PROJECT NUMBER _____ PROJECT NAME AND CRC C&D

RE: Proposed Anderson Creek C&D Landfill
Harnett County; Permit #43-03

RE: Monitoring Well Installation - Closed Out Cells
Anderson Creek Construction and Demolition Landfill
Harnett County, North Carolina

RE: Site Suitability and Construction Plan Applications
Proposed C&D Landfill Unit
Anderson Creek Landfill; Permit #43-03

REVISED WELL LOCATION MAP ANDERSON CREEK CED

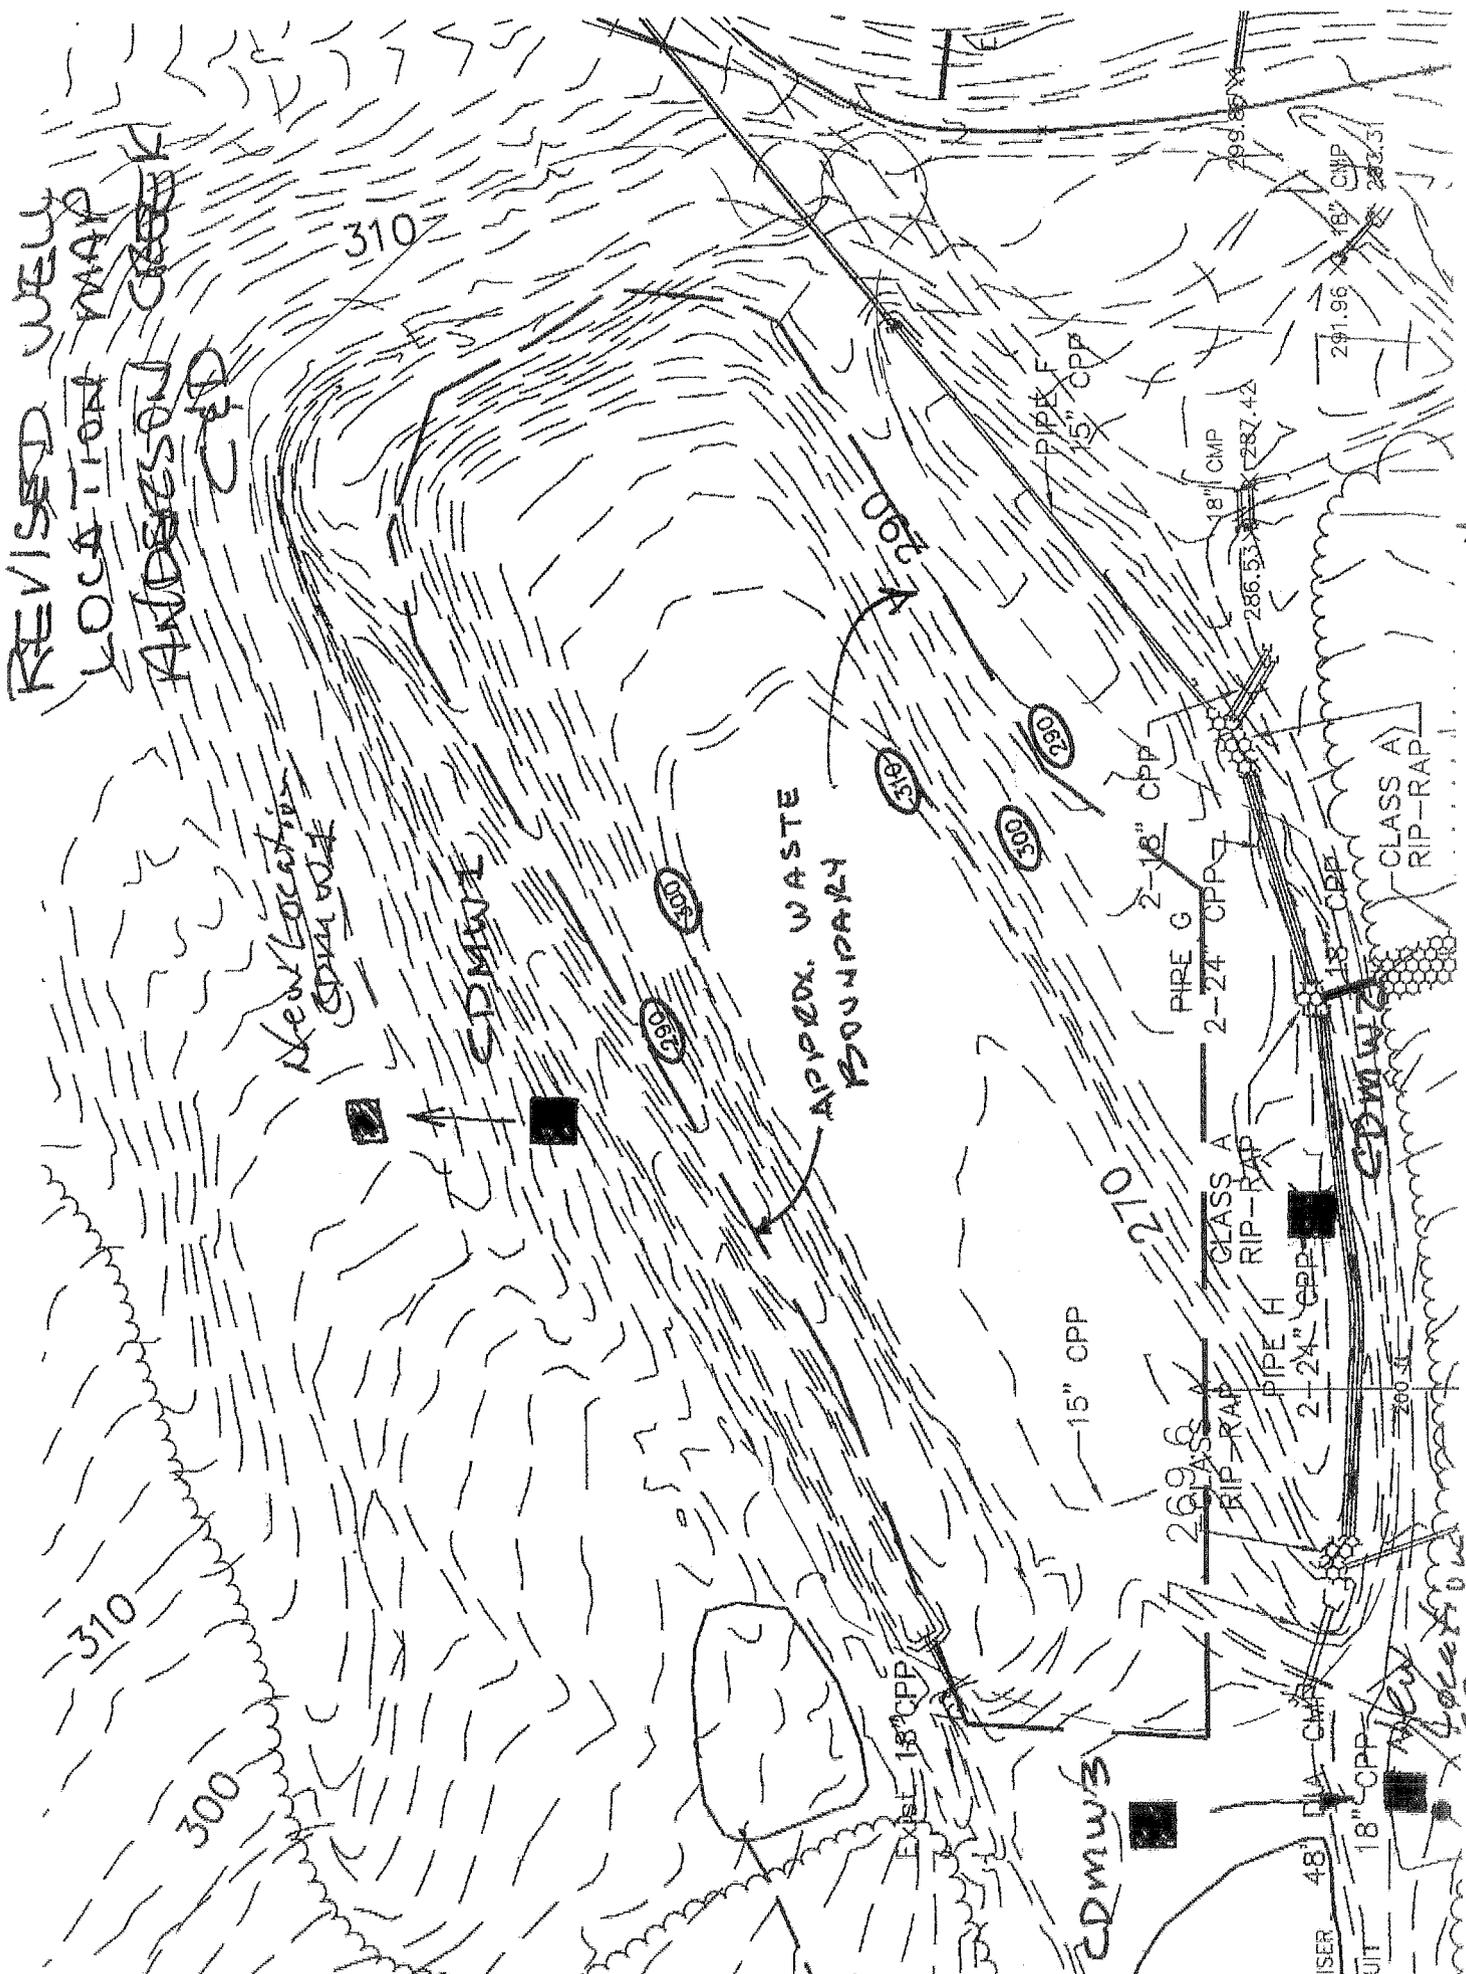
Jim - I've moved 2 of the wells
Please let me know if you
agree. Leave message if
I'm not here.
Thanks

REVISED WELL
LOCATION MAP
ANDERSON CREEK
CDP

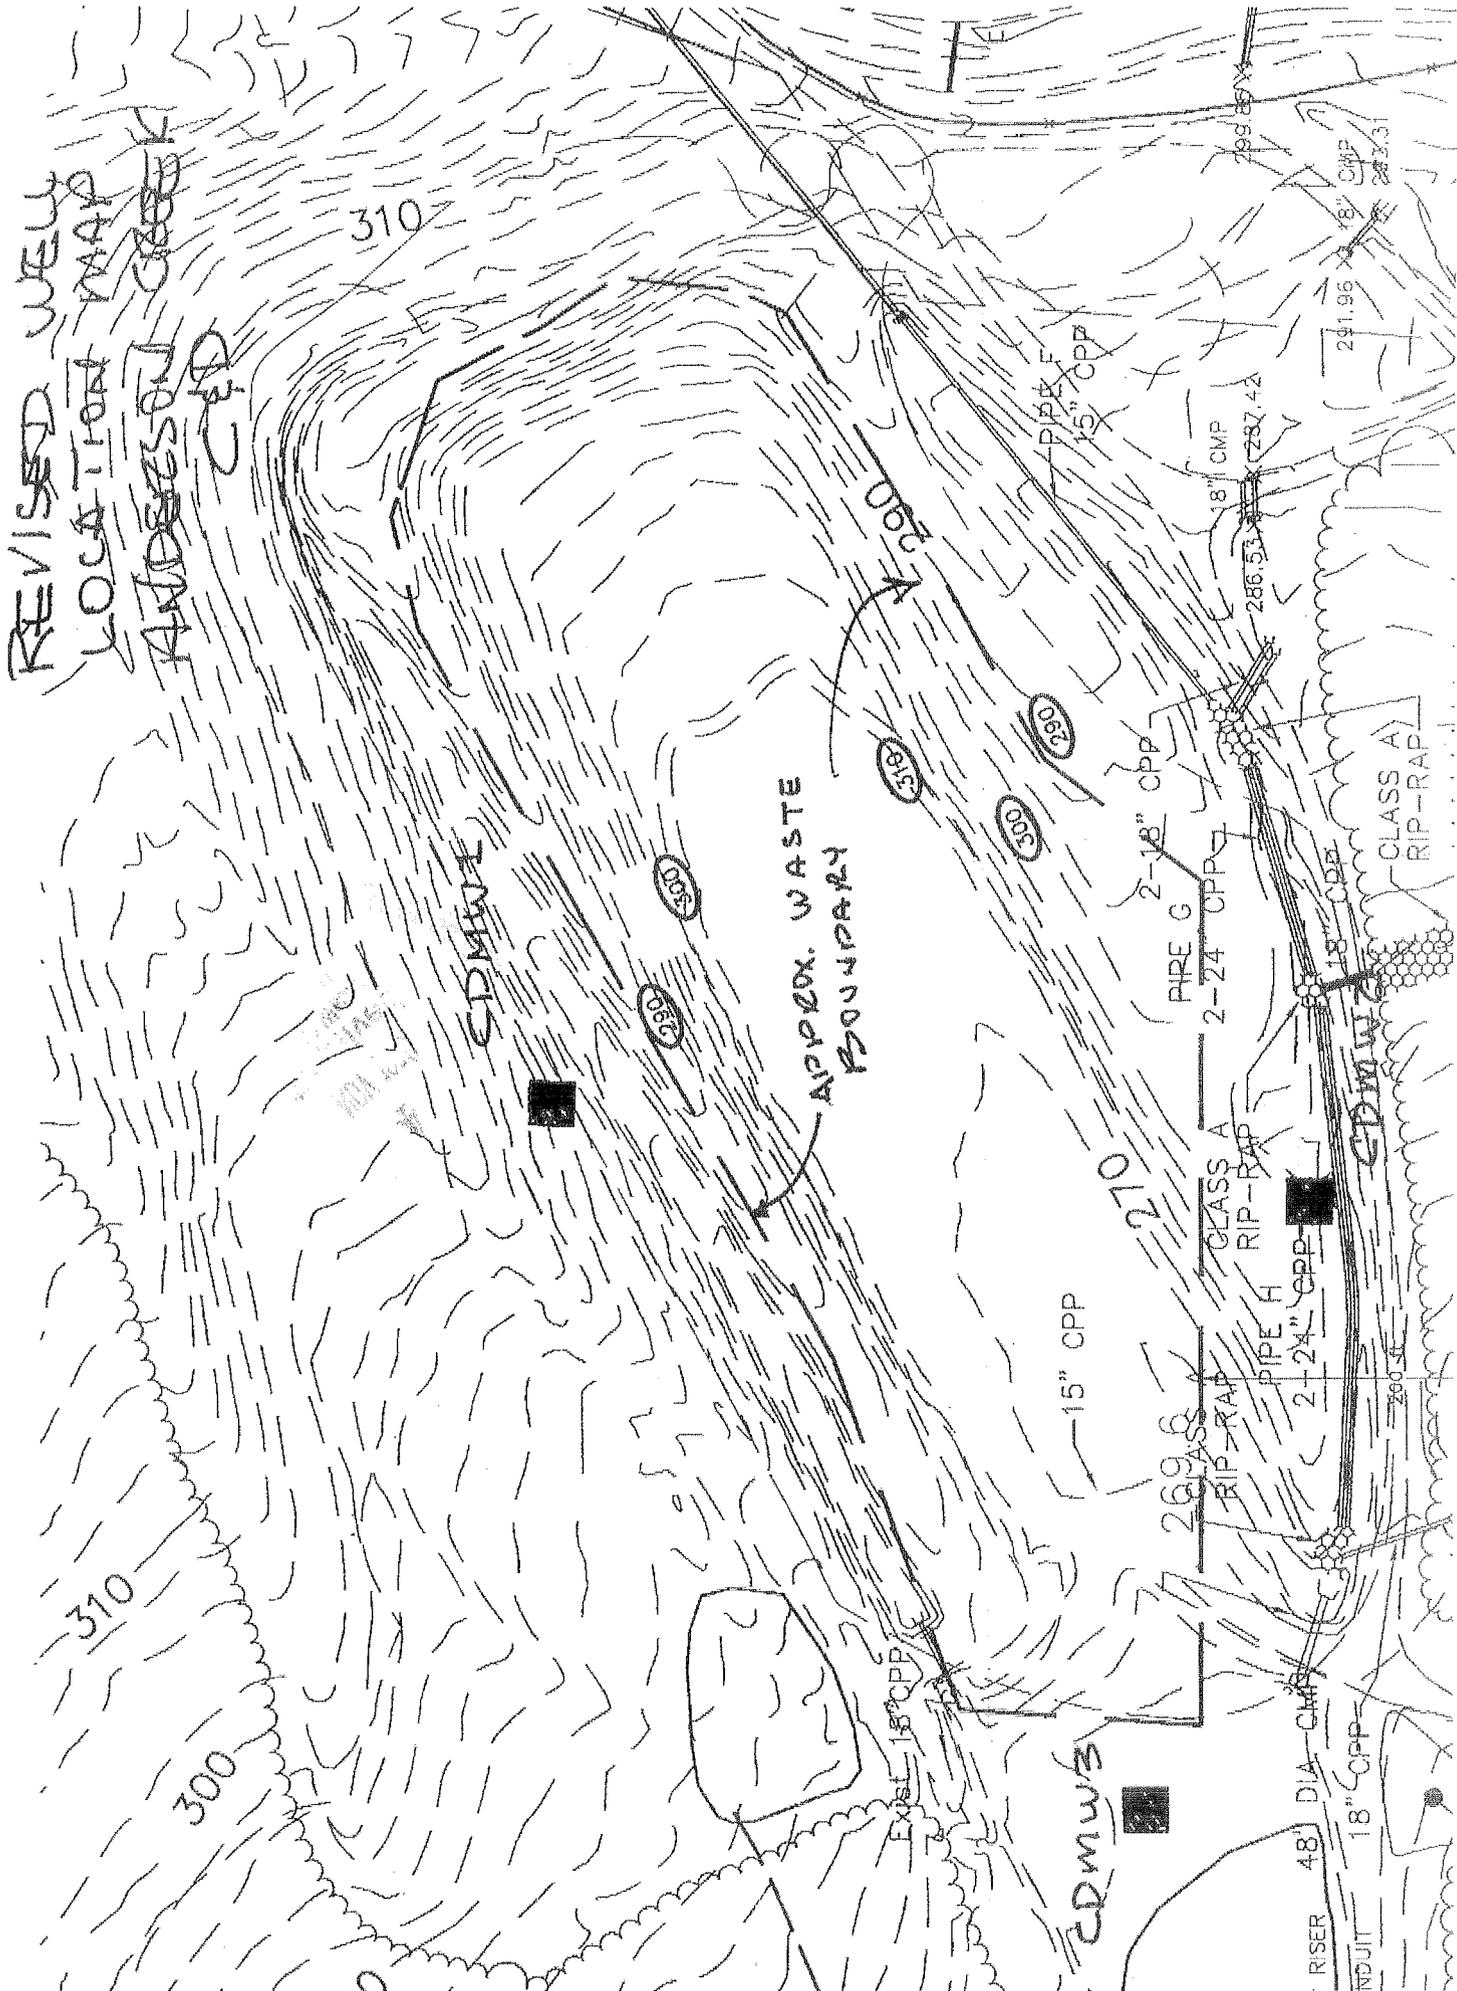
Jim - Attached please find a sketch of proposed locations for And. Crk. Mont. Wells. The problem may be in locating the down gradient well (west) of the cell. This well cannot be located very far from the waste and still not get into the pond. This area is also wet a great deal of the time. It may be impossible to logistically locate the well above the surface water runoff. We may need to field locate the well and then get approval of the location from NCDEHNR prior to installation.

I believe the info on well schematic, screening etc . is in Section 8 of the application. Do you need more information?

FIGURE 1

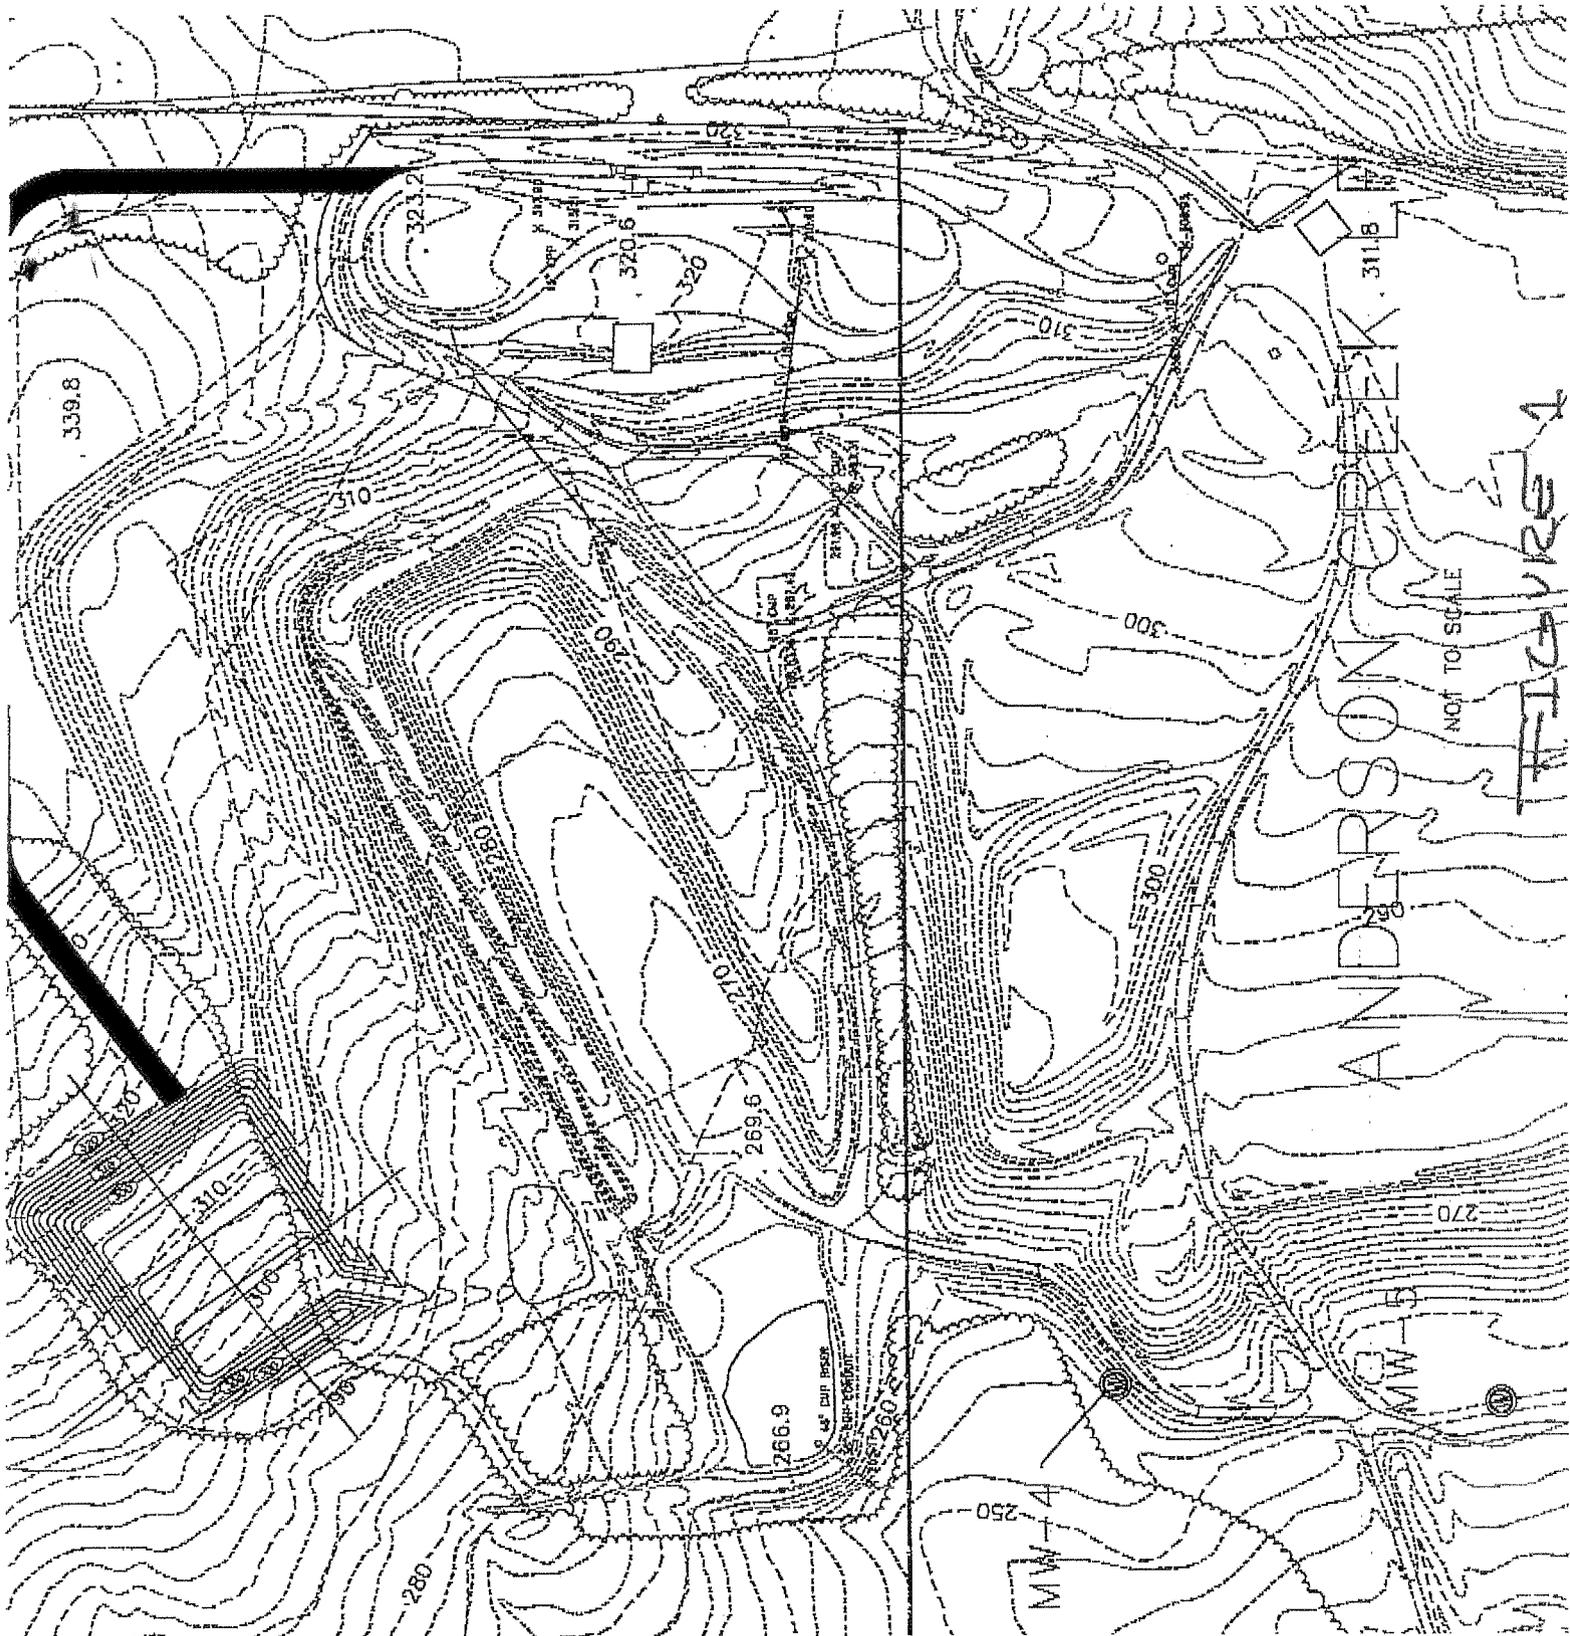
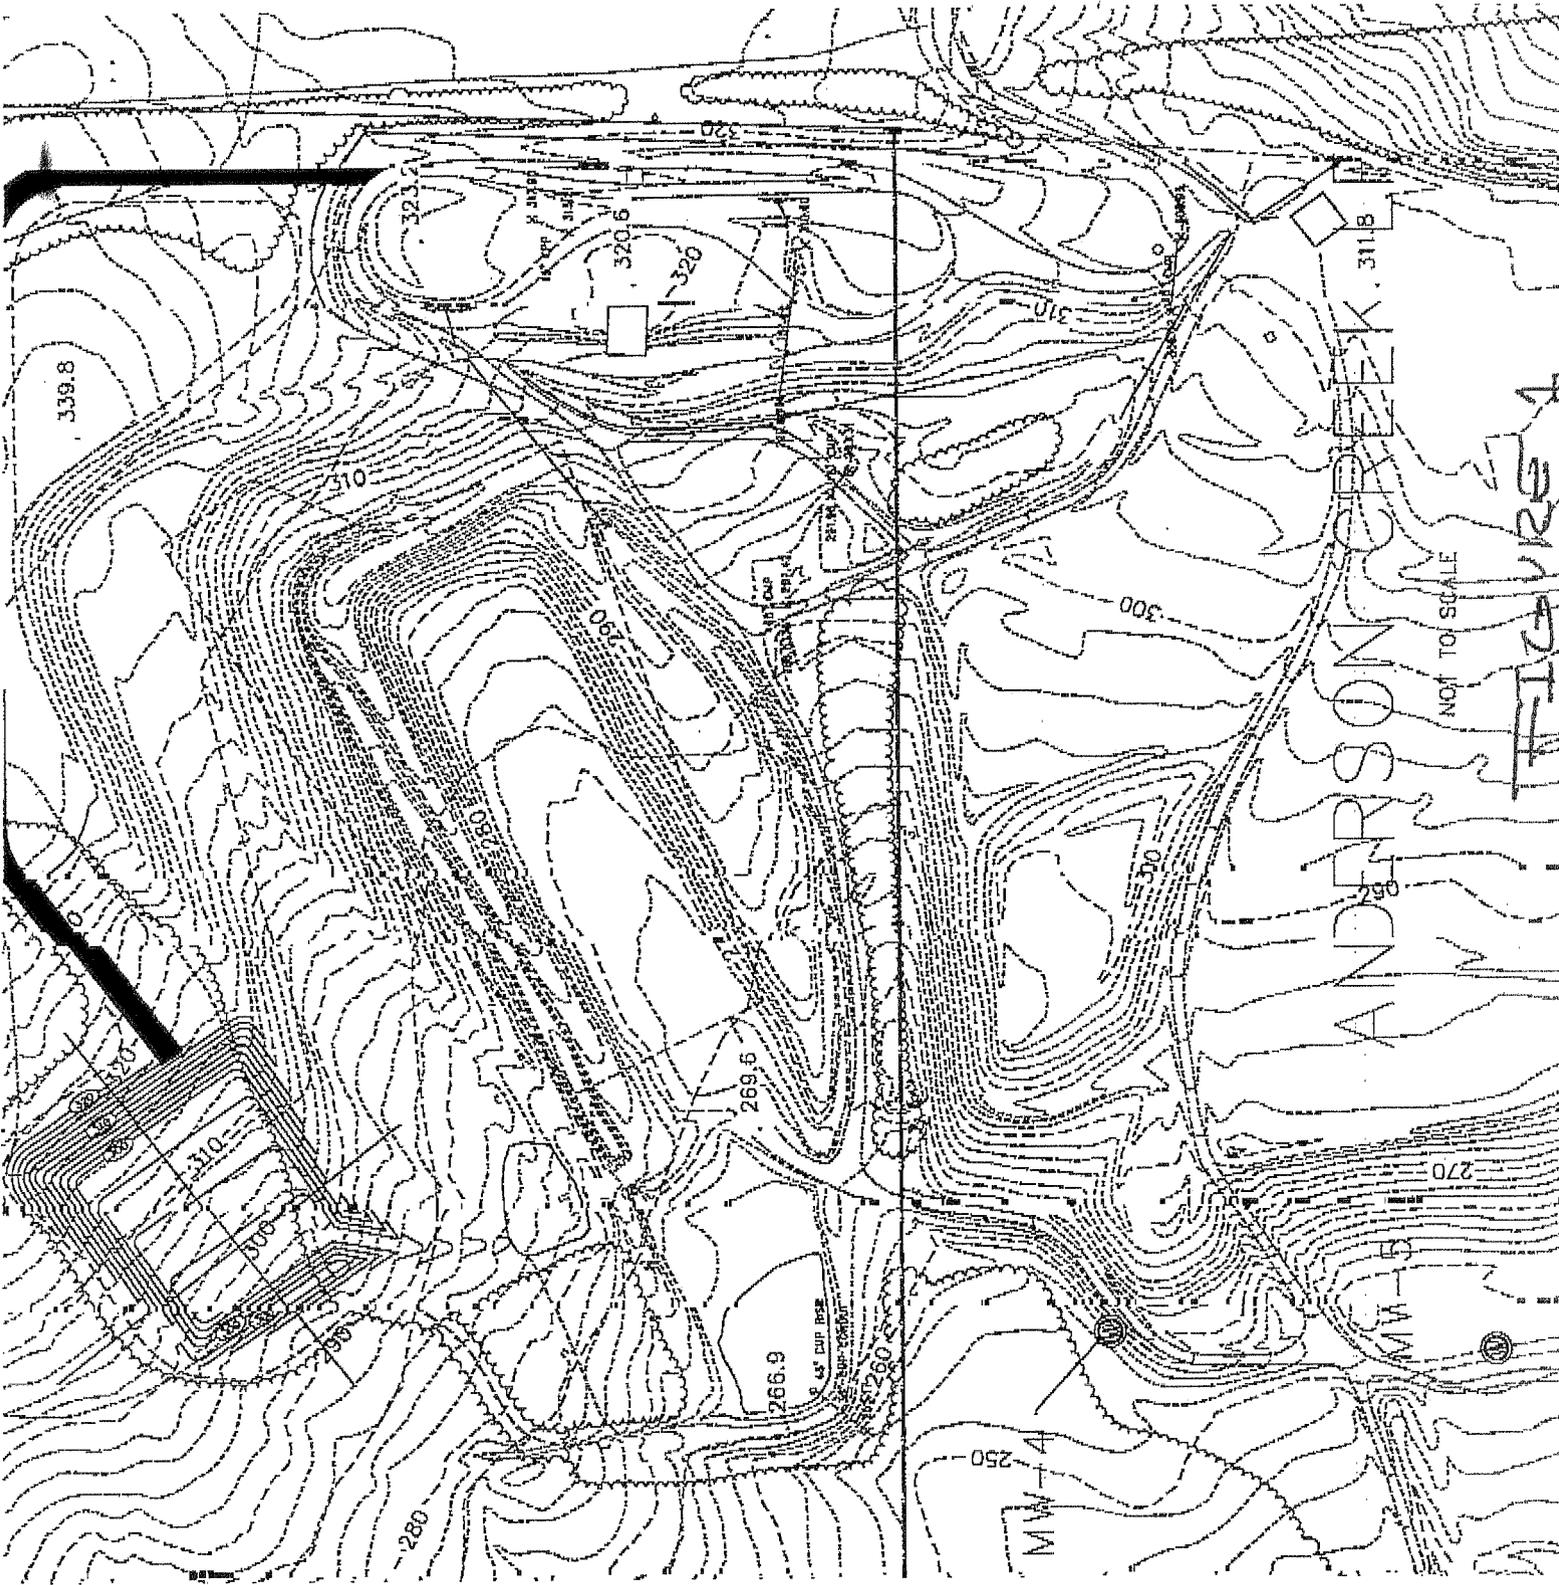
This letter requests the installation of two new monitoring wells at the Anderson Creek Landfill. These are being installed at the request of NCDEHNR in connection with the closure of the old cells. The location of the wells are shown on the attached map, as discussed in our December 19, 1995 meeting.

Included with this request is a sketch showing the location of the two monitoring wells as discussed in that December 19, 1995 meeting.

I have reviewed a proposal from McKim and Creed Engineers, P.A., dated March 12, 1996, for installation of two monitoring wells at the Anderson Creek landfill. As located on their accompanying sketch, the two proposed wells will satisfy the need for upgrading the monitoring system for final closure of the sanitary landfill units at the facility. This letter serves as authorization from the Solid Waste Section for Harnett County to install the two monitoring wells as proposed in the March 12 letter.
